HENDERSON COUNTY TECHNICAL REVIEW COMMITEE

SUBJECT: Combined Master and Development Plan for Hickory Nut Preserve

Henderson County Planning Department Staff Report

Combined Master and Development Plan Review for Hickory Nut Preserve Major Subdivision (File #2008-M02)

Map A: CCP Future Land Use

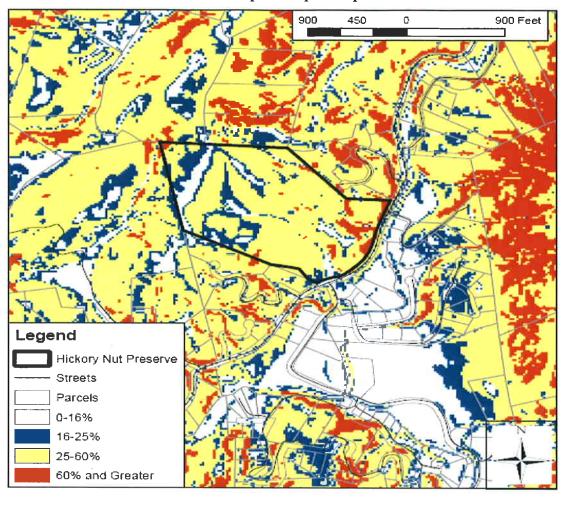
1. *Henderson County 2020 Comprehensive Plan* (CCP). The Future Land Use Map of the CCP shows the project site as being located within each of the following areas: Conservation Area and Rural/Agricultural Area (RAA) (See Map A: CCP Future Land Use Map).

Map B: Slopes Map

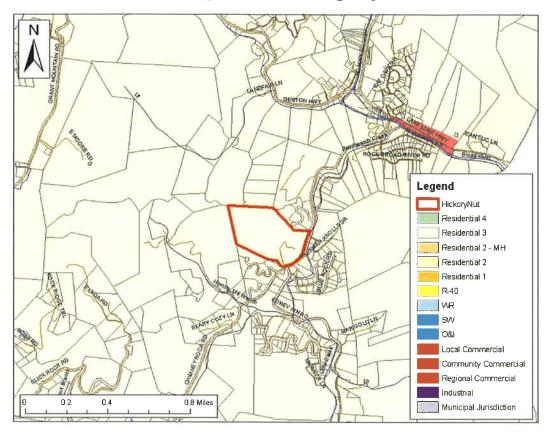
- (a) Conservation Area. The conservation area designation is applied to the eastern portion of the project site, largely due to slopes (See Map A: CCP Future Land Use Map and Map B: Slopes Map). Slopes within the project site appear to be in excess of 25 percent, with portions having slopes in excess of 60 percent. The CCP states that conservation lands "are intended to remain largely in their natural state, with only limited development," and further that "such areas should be targeted for protection through regulations and incentives" (2020 CCP, Pg. 134).
- (b) Rural Agricultural Area. The Rural Agricultural Area (RAA) designation of the Growth Management Strategy is applied to the project site. The RAA is intended to remain predominantly rural with a density of five (5) or more acres per dwelling unit (average lot sizes of five (5) or more acres per unit).
